Subject: Virgil C. Summer Nuclear Station (VCSNS) Units 2 and 3 Combined  
License Application (COLA) - Docket Numbers 52-027 and 52-028  
Response to NRC Verbal Request for Information Related to Chapter 17  
of the VCSNS Final Safety Analysis Report (FSAR).

**Verbal Request for Information 17.1-VR**

### VCSNS QAPD Part II, Section 1

#### Draft Revision 2

Figure II.1-1 - SCE&G Corporate Organization

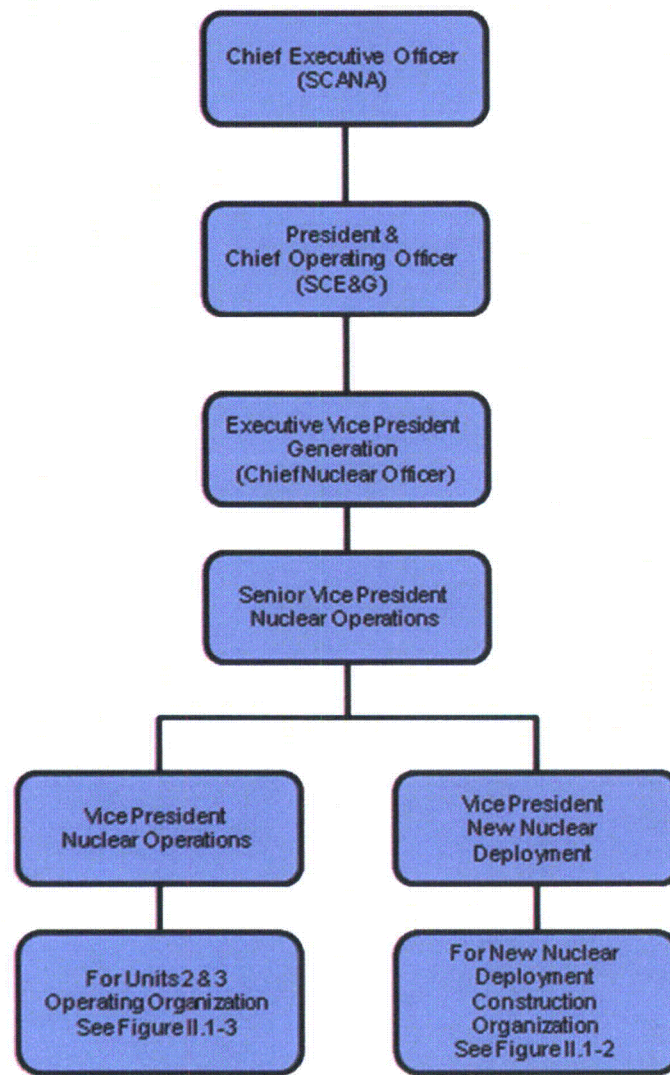
- b) The organizations responsible for Construction, Preoperational/Testing, and Operations must be fully described in Part II, Section 1 of the QAPD, including the organizational structure, functional responsibilities, and levels of authority and lines of communication for activities affecting quality.

- b) The V.C. Summer Units 2 and 3 construction, preoperational/testing, and operations organizations are described in the attached mark-up to Part II, Section 1 of the VCSNS QAPD (Attachment I). Organizational changes through October 16, 2009 have been included to be consistent with COLA Revision 2 which was submitted on January 28, 2010. Additionally, conforming changes for NEI 06-14A Revision 7 pertaining to Part II, Section 1 of the QAPD have been included for this section. For reviewing purposes, changes made to the QAPD are highlighted in red strikethrough text for deletions, and green underlined text for insertions.

The following sections describe the reporting relationships, functional responsibilities and authorities for organizations implementing and supporting the NND QA Program. The SCE&G Corporate Organization, NND Construction Management Organization, and the Operating Plant Management Organization are shown in Figures II.-1-1 ~~II~~ through Figure II.-1-32, respectively.
